LINCOLN CITY/LANCASTER COUNTY PLANNING STAFF REPORT

for May 12, 2004 PLANNING COMMISSION MEETING

P.A.S.: Special Permit #1762B
Annexation #04004
Change of Zone #04021

PROPOSAL: To annex 10.23 acres, expand the boundary of the special permit and change the zoning on a portion from AG and AGR to R-3.

SHEET
1 OF 5

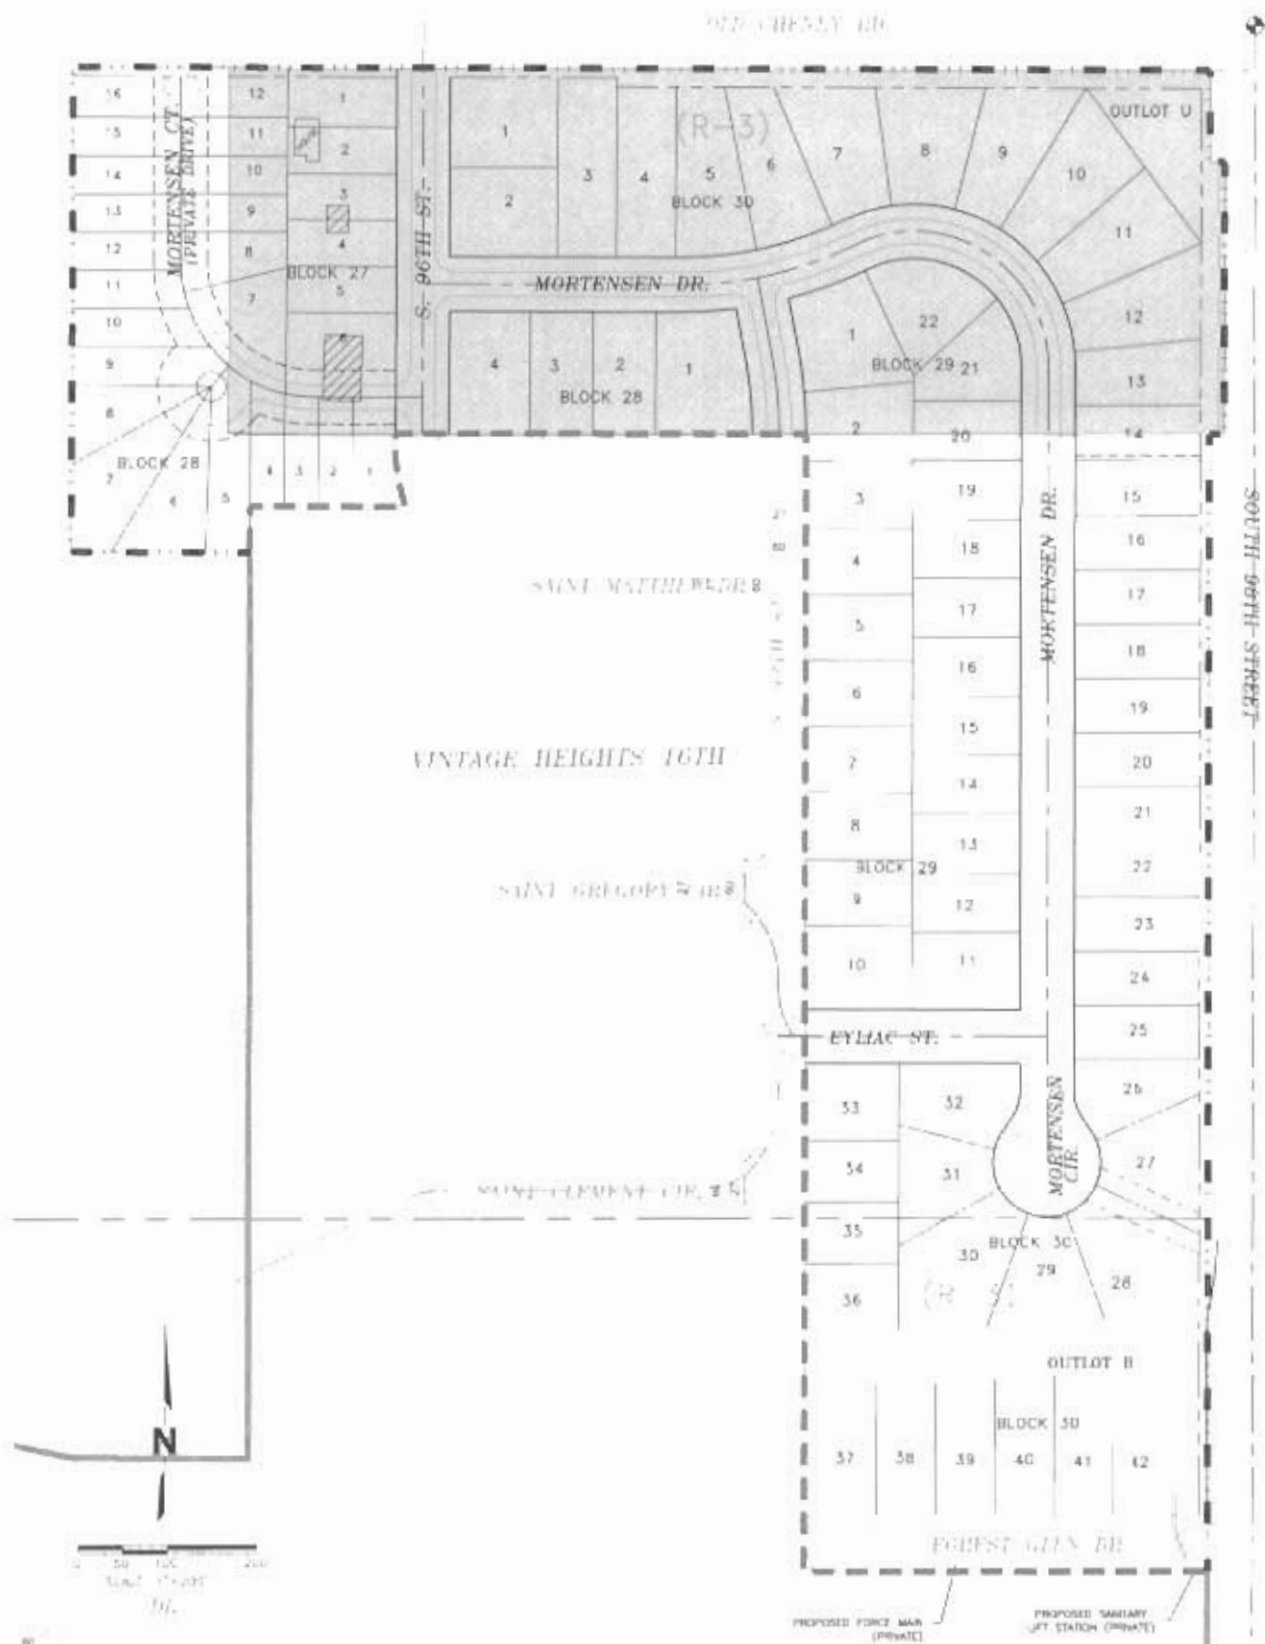
- 1.2 Revise the site plan to show:
 - 1.2.1 Correct legal description.
 - 1.2.2 Correct the total usage table in Note 13 on Sheet 1.
 - 1.2.3 The use of the lots & outlots in Note 13 on Sheet 1 must include the entire CUP.

- 1.2.6 Sheet 1 is too small and does not give the necessary information for the entire CUP. Change Sheet 1 to two sheets, similar to Vintage Heights 3rd Addition.

- 1.2.12 Add a note to the General Site Notes on Sheet 1 & 2 that states: All lots that cannot be serviced by gravity sanitary sewer shall not be final platted until such time that gravity sanitary sewer is available. Pump stations shall not be used to service these lots.

- 1.2.13 Show the location of the church, all accessory structures and the boundary of Lot 17 I. T. on Sheet 1 & 2.
 - 1.2.14 Show the location of the house and the boundary of Lot 16 I. T. on Sheet 1 & 2.

- 1.2.15 Show S. 84th St. on Sheet 1 & 2.

SHEET
3 OF 5

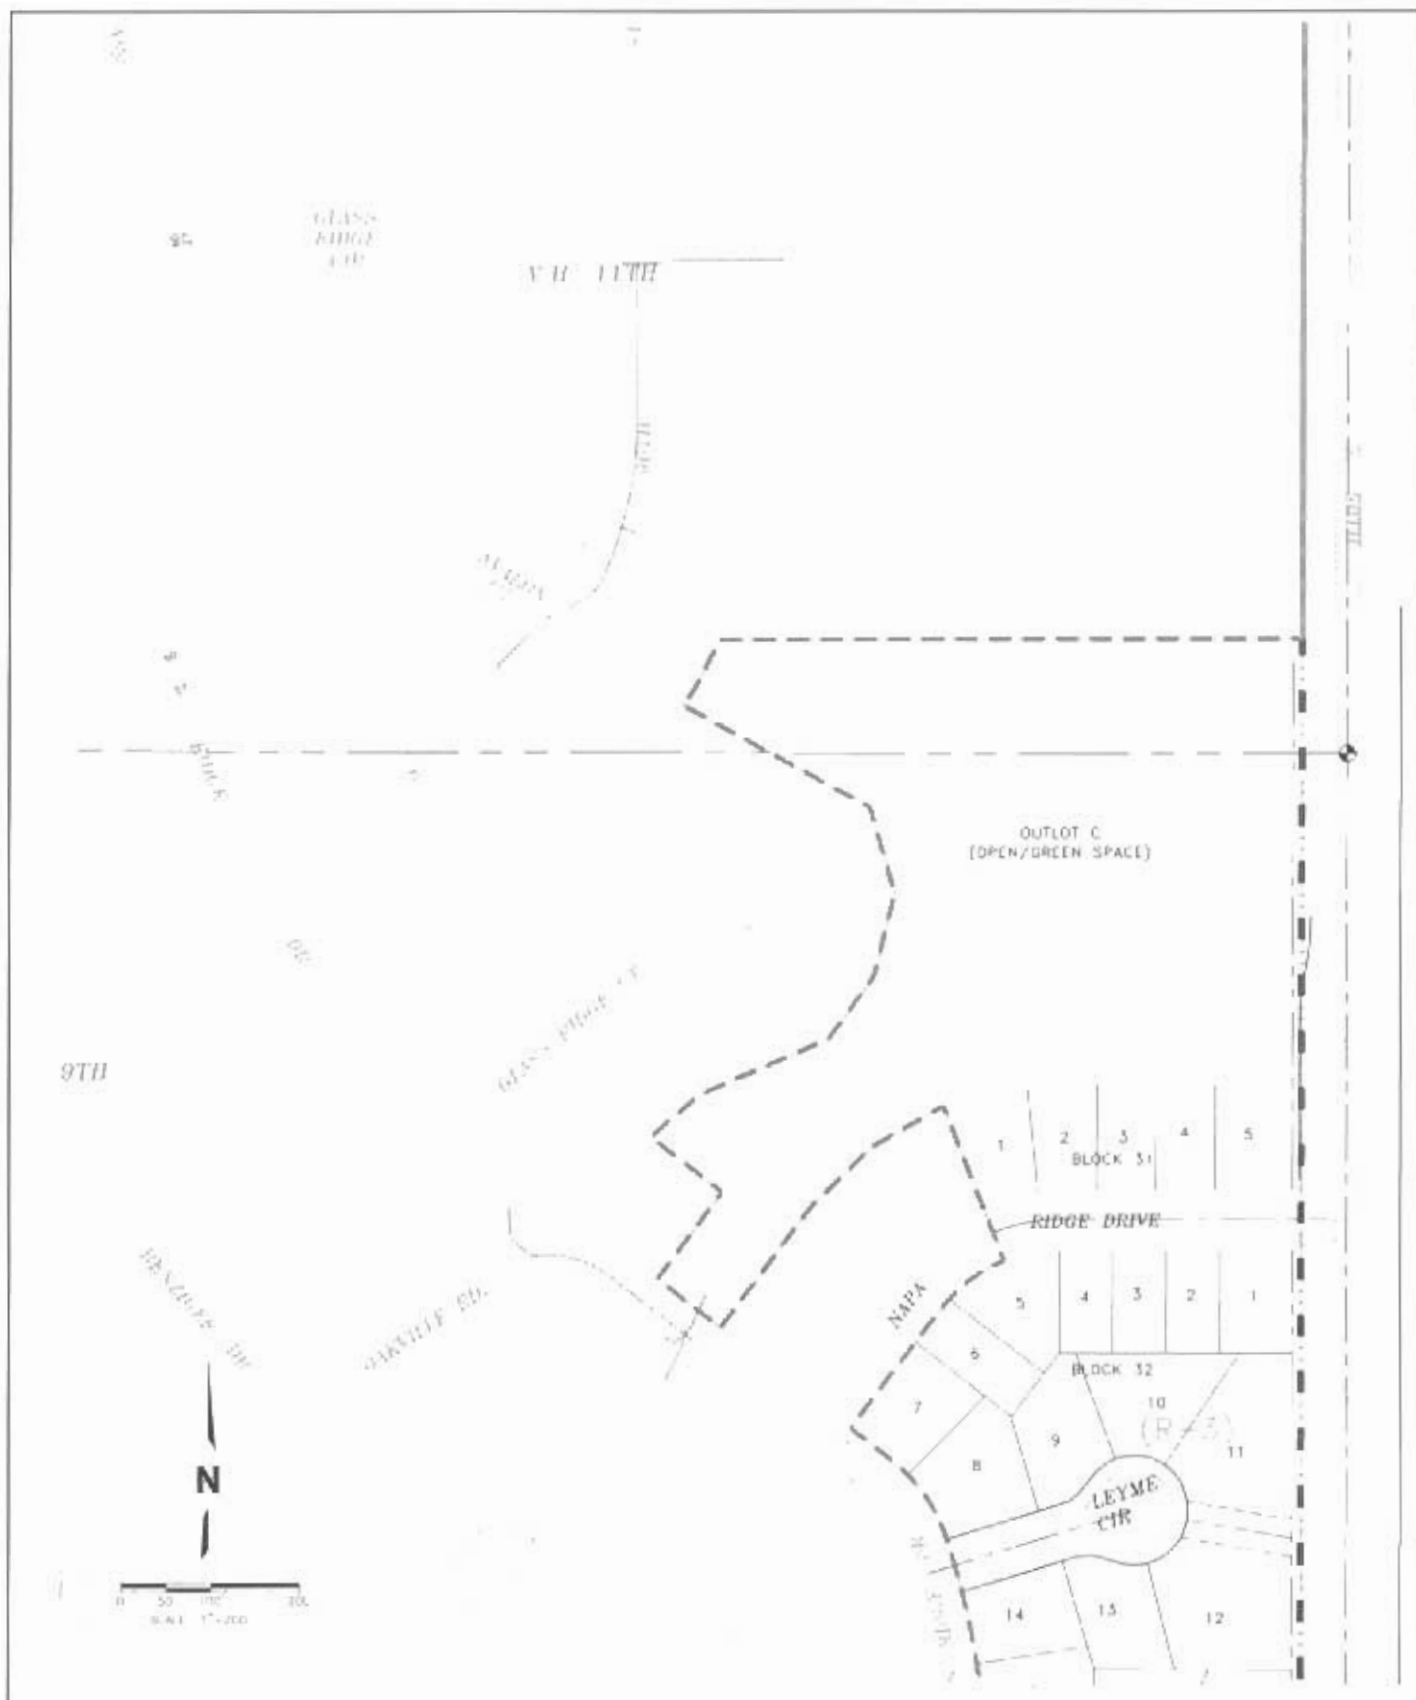
- 1.2.19 Change Block 28, east of S. 96th south of Mortensen Dr., to Block 26.
- 1.2.20 Change the block numbers for the general notes on Sheet 3 to Blocks 26-35.

- 1.2.21 Make the following correction to the General Notes on Sheet 3:
 - a. Change AGR to AG in note 2.
 - b. Delete note 4.
 - c. Amend note 7 to read, "Public sidewalks shall be installed along public and private roadways."

- 1.2.27 Identify what the shaded area is on Sheet 3. If the shaded area is to identify the annexation area, correct it to match the annexation exhibit.
